**To:** Josh Mihaly  
**From:** Kathryn Thurston, Associate Planner; 910-341-3249  
**CC:** File;  
**Date:**  
**Re:** Oleander Beer and Wine – 2nd Submittal Comments - DRAFT

**PROJECT**  
**4718 OLEANDER DRIVE**  
WILMINGTON, NC 28403  
SITE PLAN

Date: 01/28/2015  
Phase: 000  
Job Number: 100-870  
Designed by: MLD  
Drawn by: ALM  
Checked by: JWM  
Sheet Title: LANDSCAPE PLAN & EXISTING CONDITIONS SURVEY

Sheet Number  
**L1.2**  
of 2 sheets

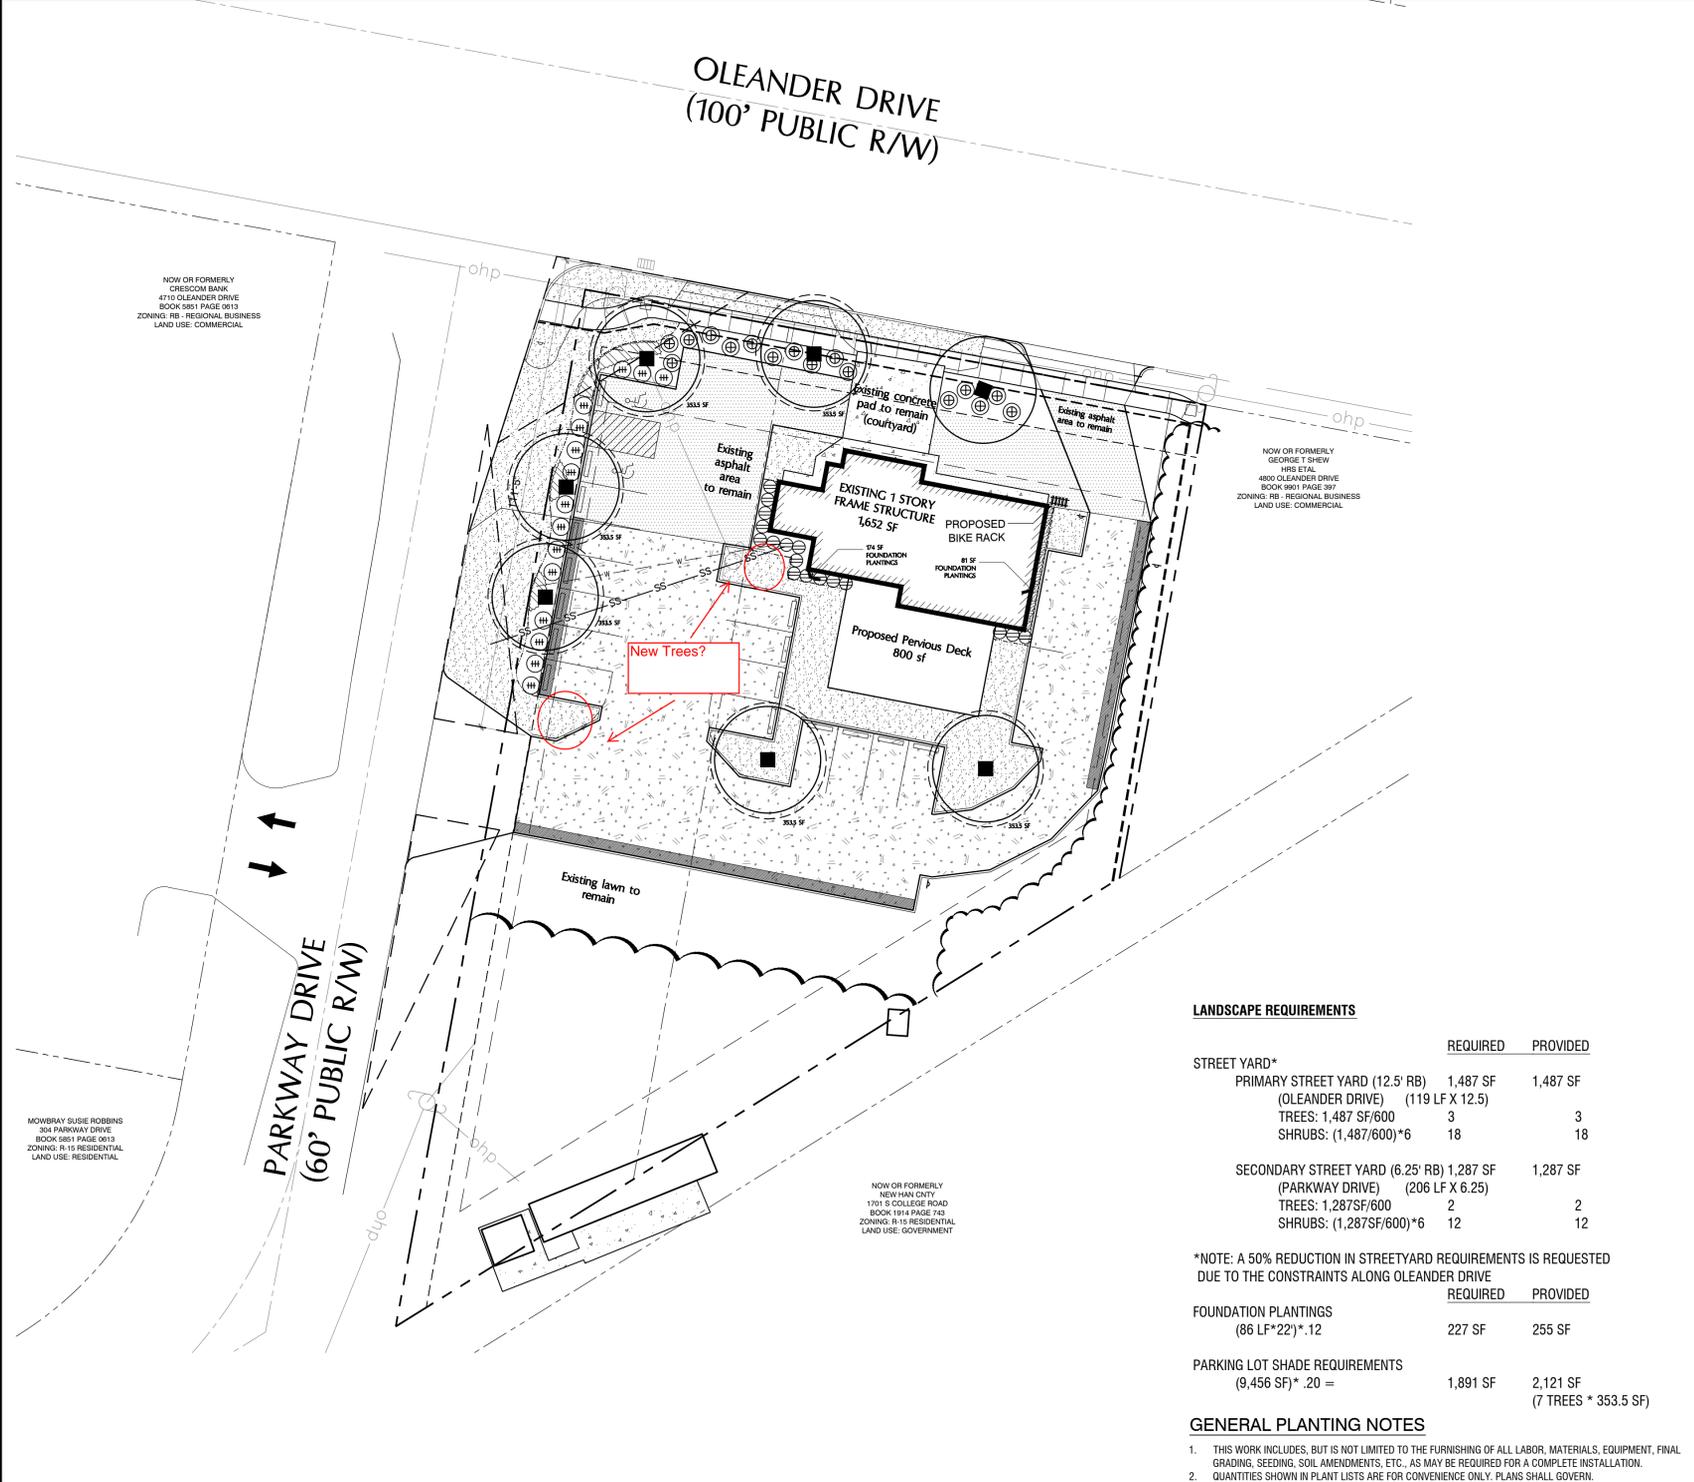
- Can you add trees within the two landscape islands not shown with trees. See attached redline.
